# DART SERVICE INSTRUCTION

TO AMEND INSTALLATION INSTRUCTIONS IIN-D412-742 REV. D  
AND INSTRUCTIONS FOR CONTINUED AIRWORTHINESS ICA-D412-742 REV. 3

REF. CANADIAN STC: SH05-37  
REF. FAA STC: SR01583SE  
REF. EASA STC: EASA.IM.R.S.01126

## PURPOSE:

**FIGURE 1: CHANGE AT FORWARD SADDLE LOCATION  
WITH DSI-9517-011 KIT INSTALLED**

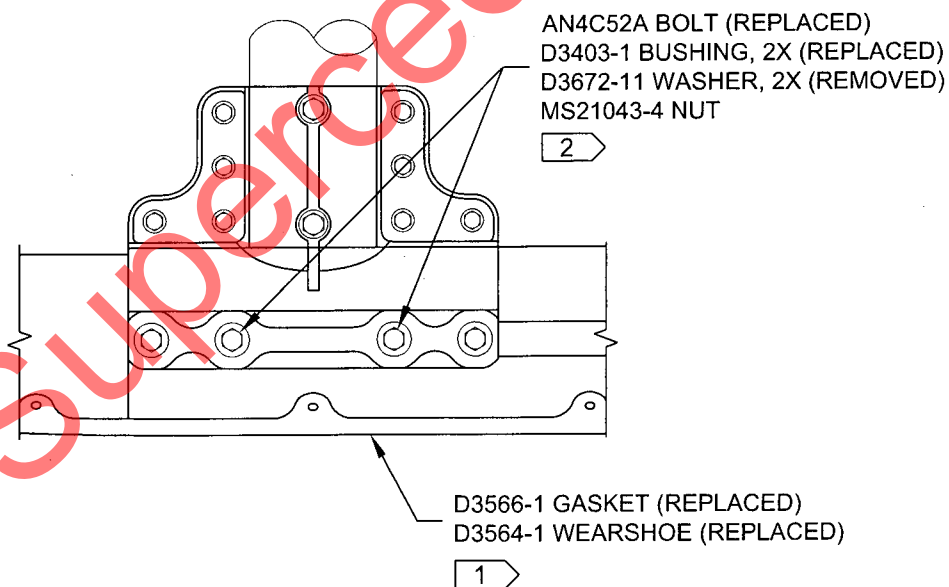
2. Remove qty.(4) AN4C52A Bolts, D3403-1 Bushings, and qty.(8) D3672-11 Washers as indicated in Figures 1 and 2 of this service instruction.
3. Inspect the skidtube and saddles per Chapter 5 of ICA-D412-742.

4. Seal existing inserts located on both sides of the skidtube in area shown in Figures 1 and 2 of this service instruction using Sikaflex -241/-291 or Proseal 890 or MIL-S-8802 Class 2B sealant.

5. Locate the DSI-9517-011 Wearplate Kit as shown in Figure 1 and 2 of this service instruction.
6. Transfer drill qty.(2) Ø0.438 hole from the skidtube/saddle to the D4095-041/-043 Wearplates Assemblies. Deburr. Touch up finish per Item 5.2.14 of ICA-D412-742 as required.

IS:

WAS:

7. Install the DSI-9517-011 Wearplate Kit using the same AN3C hardware as shown in ICA-D412-742. Torque to 15-25 in-lbs (1.7-2.8 N-m).
8. Install D3403-5 Bushings and AN4C53A Bolts in lieu of D3403-1 Bushings and AN4C52A Bolts removed at step 2 above. Ensure that the nuts on the AN4C Bolts are on the inboard side of the skidtube. Torque to 50-70 in-lbs (5.7-7.9 N-m).

**FIGURE 2: CHANGE AT AFT SADDLE LOCATION  
WITH DSI-9517-011 KIT INSTALLED**

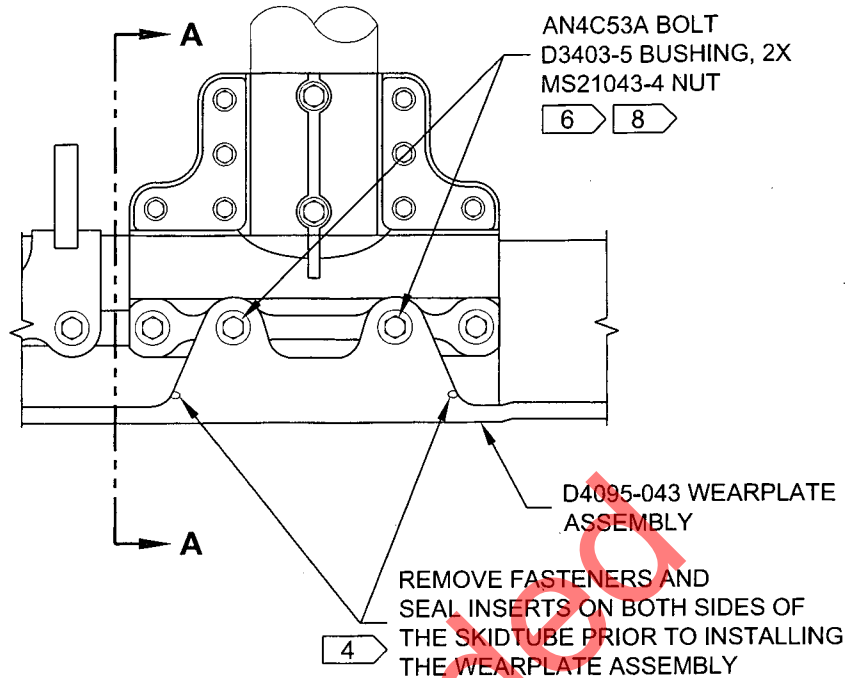
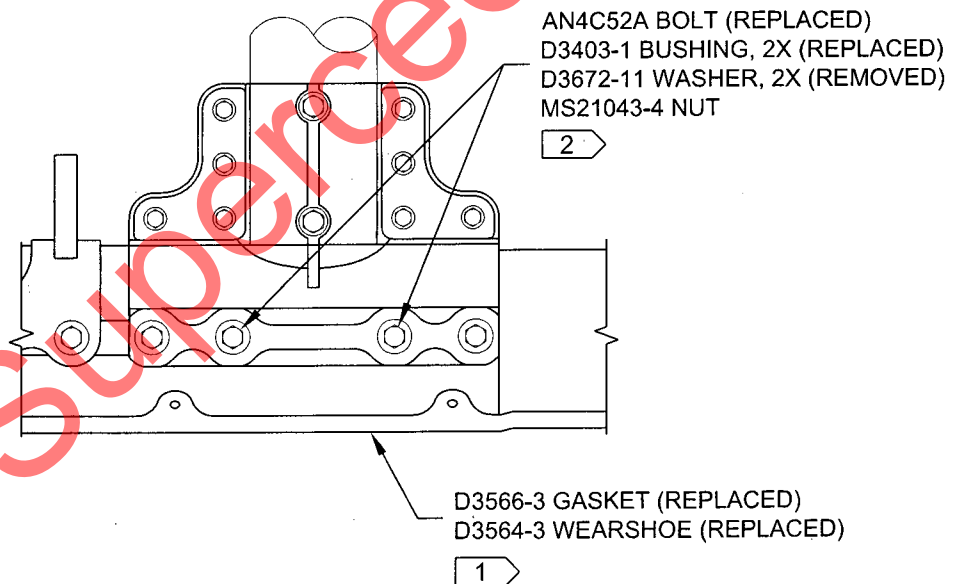
IS:

WAS:

### SECTION A-A

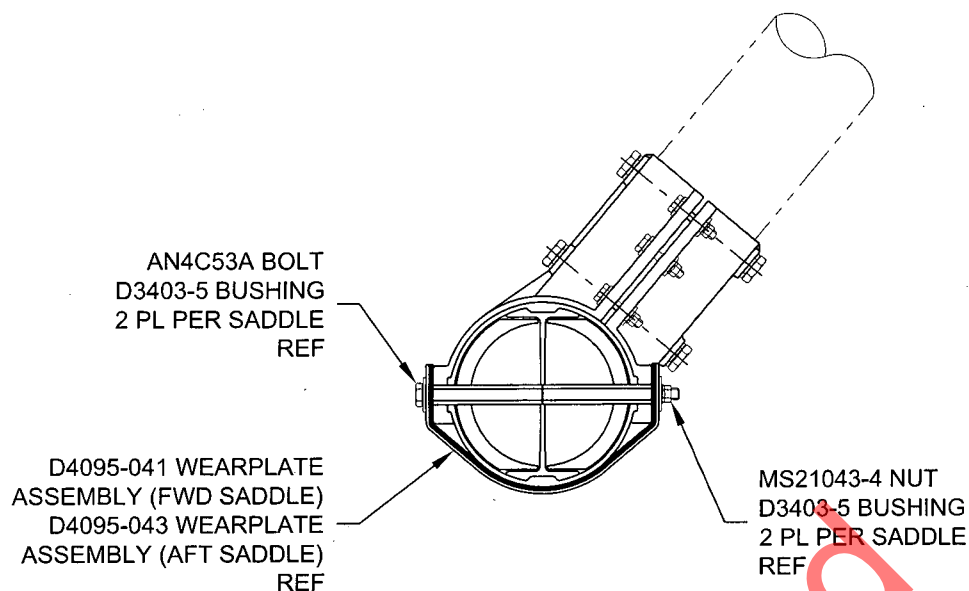
The purpose of this service instruction is to introduce an alternate wearplate installation for the D412-742-011/-013 Skidtube Installations at CHG 006 or earlier. D412-742-011/-013 at CHG 007 or later have incorporated the new Wearplate kit. The new DSI-9517-011 Wearplate Kit consists of new wearplates destined to replace existing D3564-1/-3 Wearshoes and eliminates the need for D3566-1/-3 Gaskets. The components in the DSI-9517-011 Wearplate Kit are as defined in the parts list on sheet 4 of this service instruction.

#### DSI-9517-011 PARTS LIST:

QTY -011	PART NUMBER	DESCRIPTION
X	DSI-9517-011	WEARPLATE KIT
8	D3403-5	BUSHING
1	D4095-041	WEARPLATE ASSEMBLY
1	D4095-043	WEARPLATE ASSEMBLY
4	AN4C53A	BOLT
